Comal County Environmental Health OSSF Inspection Sheet

Permit of Authorization to Construct an On-Site Sewage Facility Permit Valid For One Year From Date Issued

Permit Number: 118213
Issued This Date: 02/19/2025
This permit is hereby given to: DIMEO INVESTMENTS, LLC

LIST OF DEFICIENCIES AND/OR REQUIRED ITEMS/WITH RESPONSE

SEPTIC TANK LAYOUT:

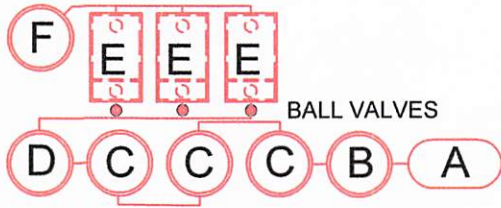
There is a typo on the number of gallons for the trash tank on the attached page (highlighted). Please revise as needed and resubmit.

- A = 1500 GAL. GREASE TRAP
- B = 3000 GAL. TRASH TANK
- C = 3 - 3000 GAL. AERATION TANKS
- D = 3000 GAL. EQUALIZATION TANK
- E = 3 - 1500 GAL. AEROBIC TREATMENT PLANTS
- F = 3000 GAL. PUMP TANK W/DUAL PUMPS
- G = CONTROL VALVE
- H = CHECK VALVE

REVISED MAINTENANCE AND CORRECTED TANK SIZE.
THX,
GREG

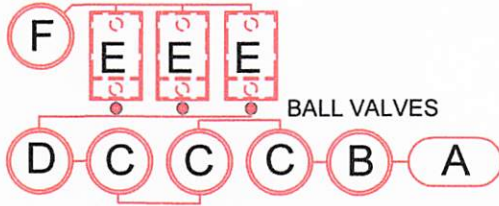
There is a typo on the number of gallons for the trash tank on the attached page (highlighted). Please revise as needed and resubmit.

- F = 3000 GAL. GREASE TRAP
- B = 3000 GAL. TRASH TANK
- C = 3 - 3000 GAL. AERATION TANKS
- D = 3000 GAL. EQUALIZATION TANK
- E = 3 - 1500 GAL. AEROBIC TREATMENT PLANTS
- F = 3000 GAL. PUMP TANK W/DUAL PUMPS
- G = CONTROL VALVE
- H = CHECK VALVE
